Part 21 (PAR)

VALVE PLUNGER GUIDE MALFUNCTION

10 CFR PART 21 Notification:

AUTOMATIC VALVE	NUMBER: D7174-003	Page 1 of 3
TITLE: CORRECTIVE ACTION	LOCN: I:\WORD\DOCUMENT\D7174003.DOC	DATE: 10-21-1999
SUBJ: CORRECTIVE ACTION	TYPE: FORM	DEPT RESP: DQA
		REV: F-CN8020

Illustration 1: Pictorial of Valve showing Area where damage was noted:

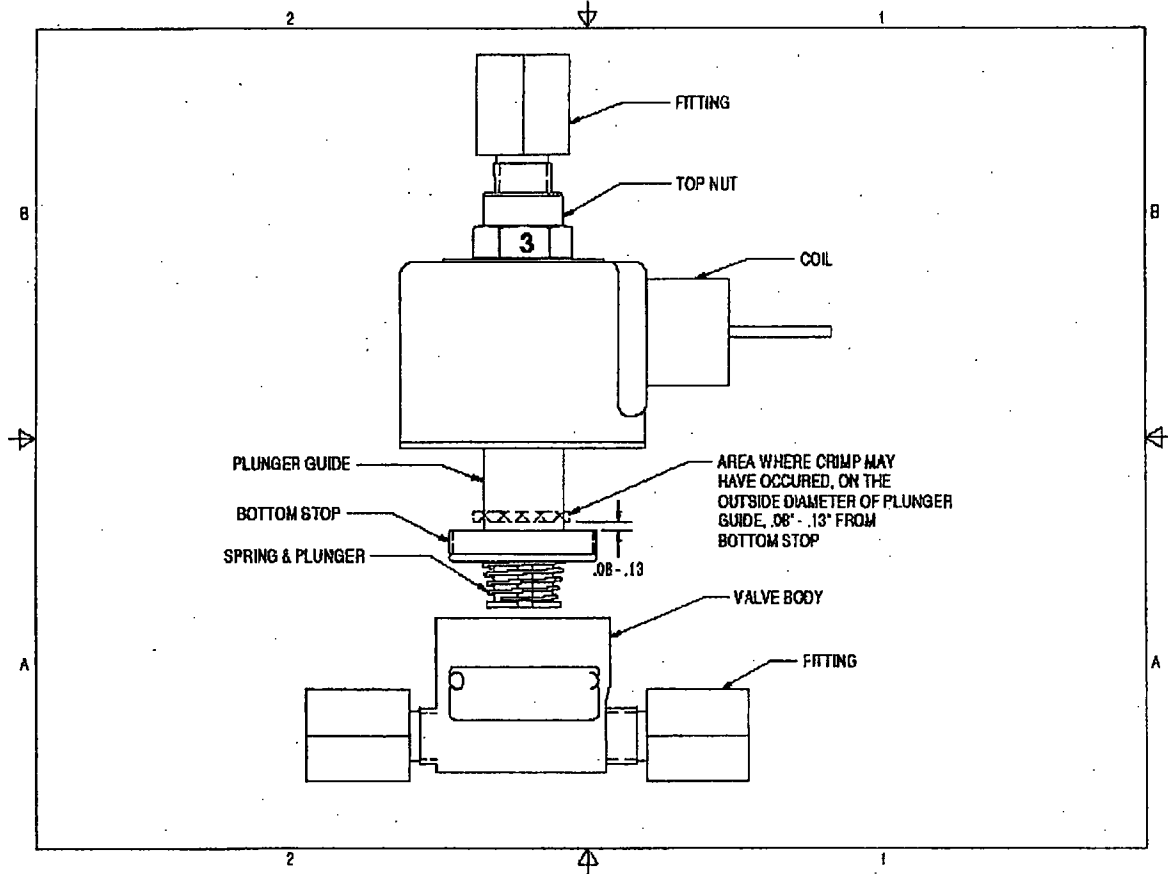
1. Team Working on Problem:	Leader: Tom Troy	Members:
Brian Bielat, Kelly Morris, Kevin Armstrong		
2. Describe Problem (Initial Concern and Symptoms):		
Valve, serial number 73386, does not consistently return to the closed position.		
Contain Symptom (Action):		
Return rebuilt unit to the customer. Notify affected customers of the problem and inspection required. See Illustration 1 and Photograph 1.		
Approved by:	Title: President	Date: 03.23.11

4. Root Cause/s of Problem: 10 CFR Part 21 Report Required: YES		
U0204GBBR-AA is a valve constructed with 3/8 inch NPT adaptors inserted into 1/4 inch NPTF ports.		
The adaptors are installed after the basic unit is built and tested. The adaptors are then leak checked; but the valve is not functionally re-tested after the installation of the adaptor.		
The solenoid plunger guide was accidentally crimped when the adaptor fitting was installed.		
The crimp in the plunger guide may interfere with the movement of the plunger. If the interference prevents the plunger from completing its full stroke, the valve will not return to its closed position. If this occurs, the valve will fail to close.		
The failure was noted when Exelon staff tested the valve, prior to installation.		
Approved by:	Title: President	Date: 03.23.11

5. Corrective Action:		
Install all fittings in the valve body prior to the installation of the plunger guide into the body.		
Approved by:	Title: President	Date: 03.23.11

6. Implementation:		
CN 9780 specifies the assembly order of the fittings into the valve body and plunger guide. This is done prior to assembly of the plunger guide into the body.		
Approved by:	Title: President	Date: 03.23.11
